Docket Number:	23-OPT-01
Project Title:	Fountain Wind Project
TN #:	262352-2
Document Title:	Additional Administrative Records for the Fountain Wind Proceeding_Part 2
Description:	N/A
Filer:	Ngoc Tran
Organization:	California Energy Commission
Submitter Role:	Commission Staff
Submission Date:	3/25/2025 3:27:14 PM
Docketed Date:	3/25/2025

REPORT TO THE SHASTA COUNTY PLANNING COMMISSION

<u>PROJECT IDENTIFICATION:</u>	<u>REGULAR ITEM</u>	MEETING DATE	AGENDA ITEM #
USE PERMIT 16-007 (FOUNTAIN WIND PROJECT) OWNER: SHASTA CASCADE TIMBERLANDS, LLC APPLICANT: FOUNTAIN WIND, LLC MONTGOMERY CREEK AREA		06/22/21	R2

TN250058

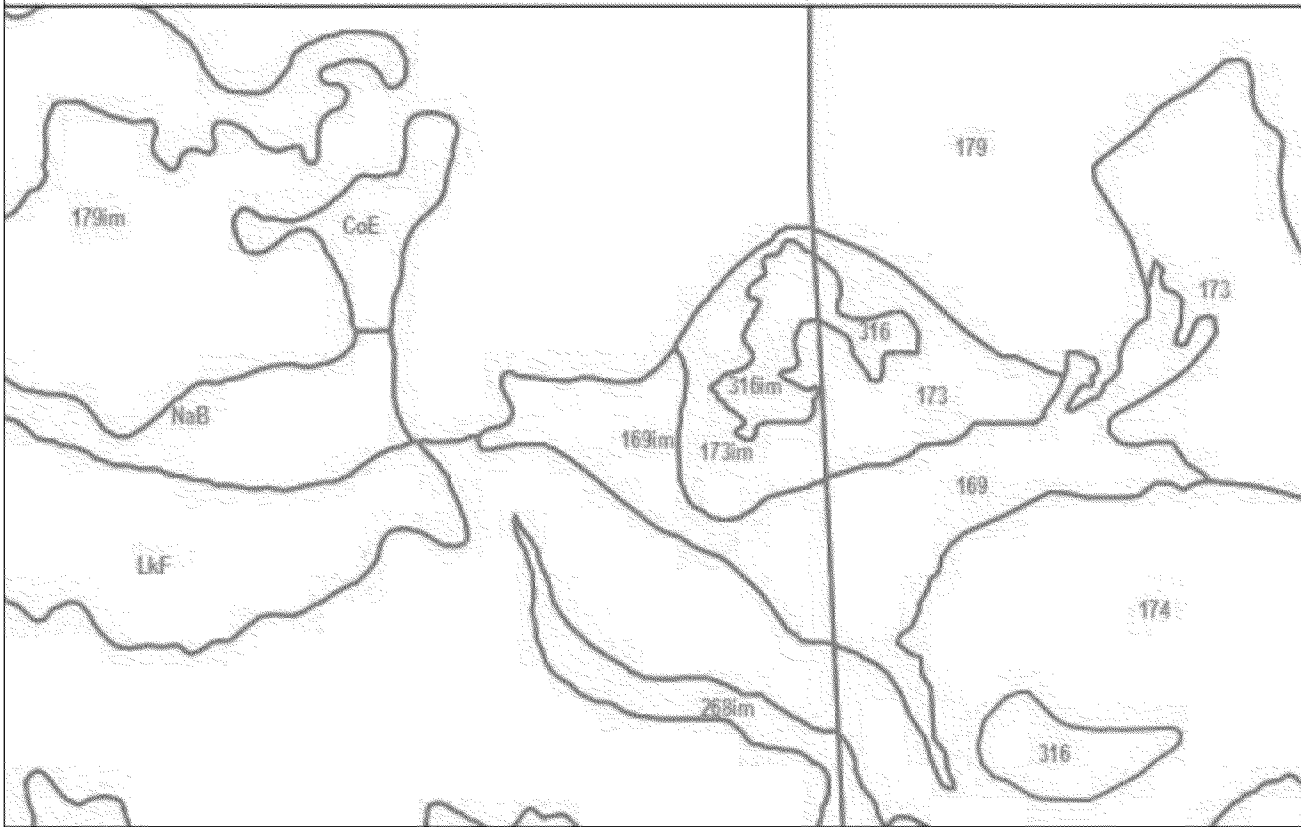
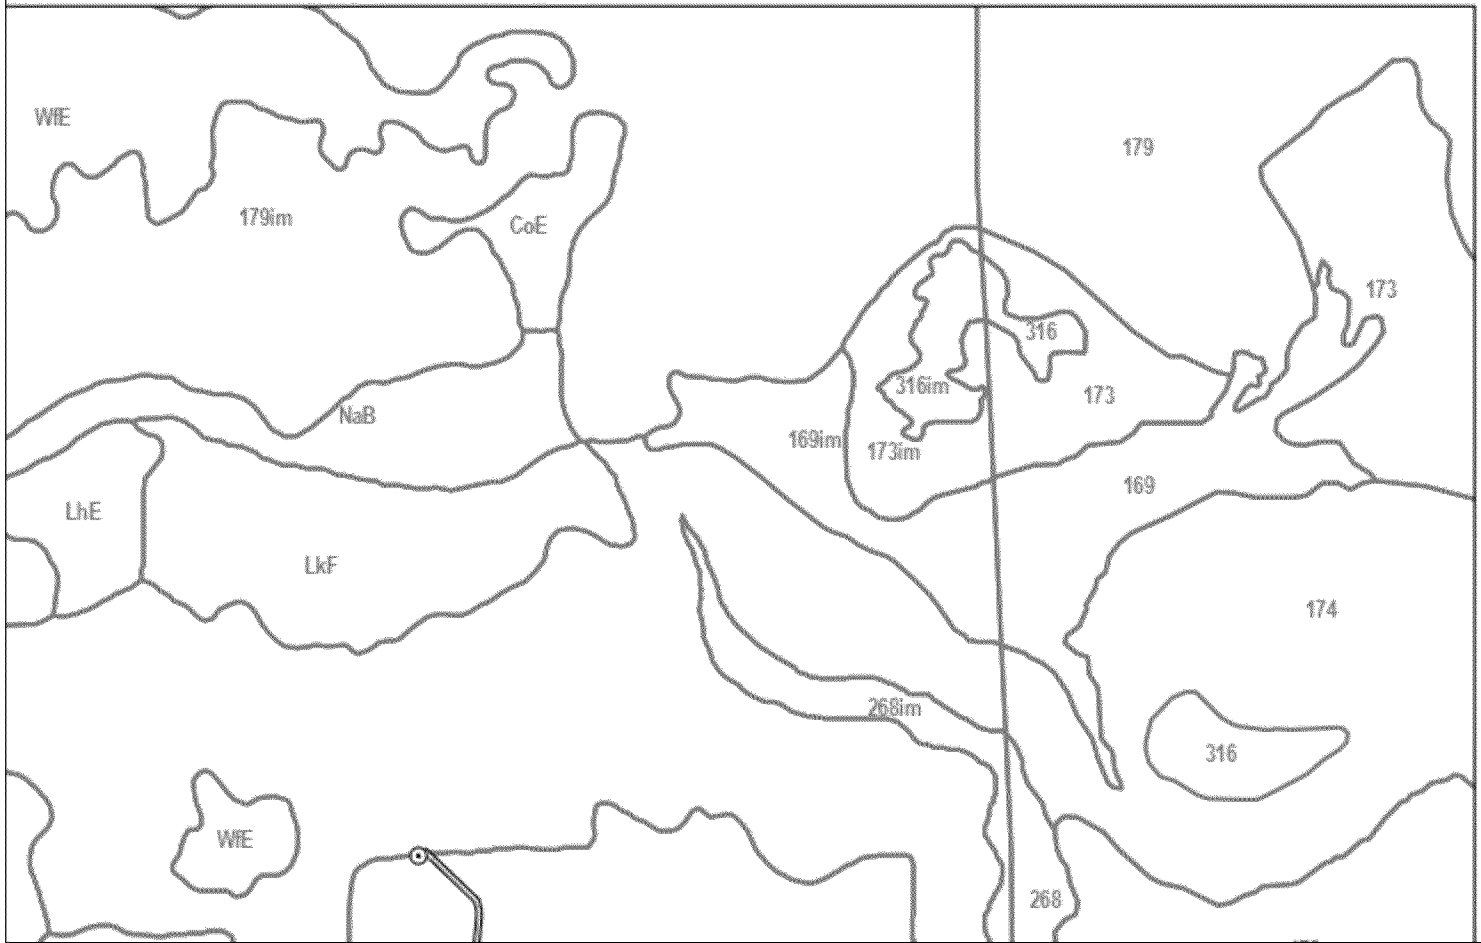
As an example, below are screen shots of the same portion of Figure 2 (Soils Map, TN250058) and Figure 3 (Soil Erosion K-Factor Map, TN250060).

I did review all the Figure 3 maps and the K-Factor shading seen in the legend is not shown on any of the maps.

It might be helpful if Ms. Burns could identify exactly where the K-Factor shading is displayed on the Figure 3 maps.

I reuploaded the figure to the docket. Let me know if for some reason it doesn't look like this:
